**Amendments to the Drawings:**

Serial No. 10/723,701  
Art Unit: 2829  
Page 9

### REMARKS

Figure 1

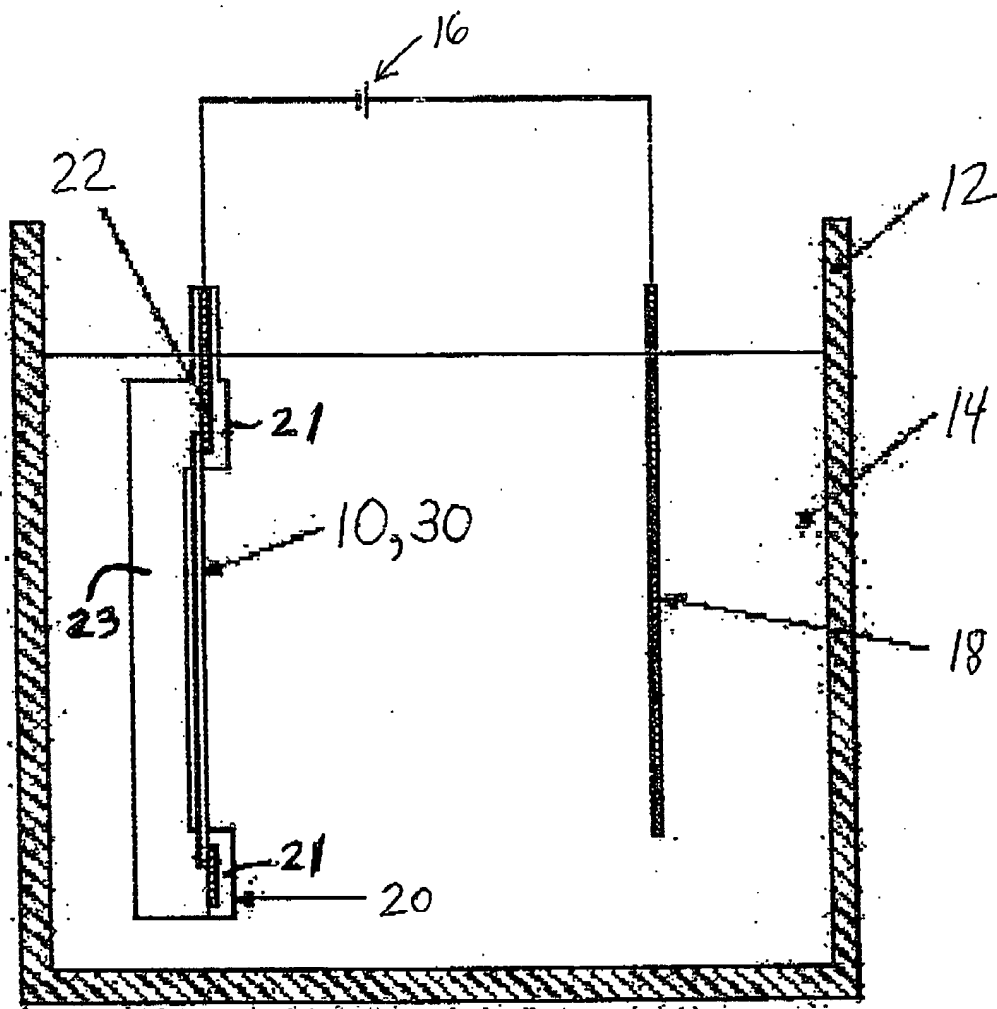
In Figure 1, please reference numerals "21" and "23" and associated lead lines;

Figure 1 and the specification have been amended to clarify that the contact ring is made up of two portions and one of the portions includes electrical contacts. Figure 2 has been revised to clarify the wafer structure. One having ordinary skill in the art would have readily known that the original Figure 2 was in error because the circuit 38 cannot be provided as being floating off the substrate, and one having ordinary skill in the art readily knows that a wafer is continuous. Figure 4b has been amended to clarify what portion of the contact ring is being depicted.

Figure 2

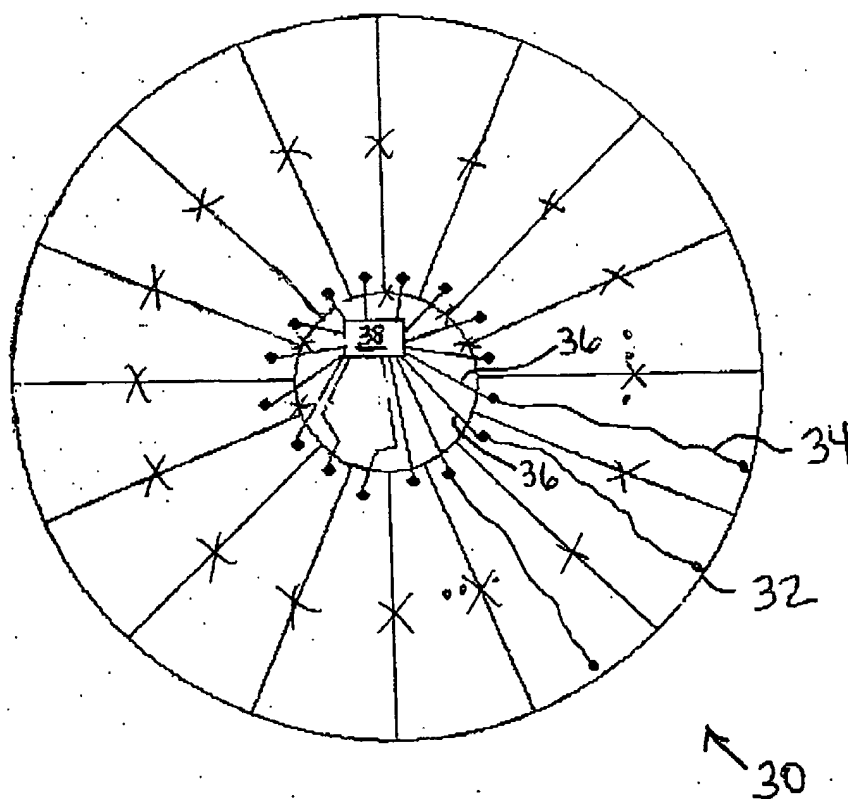
In Figure 2, please redraw as shown on the enclosed sheet; and
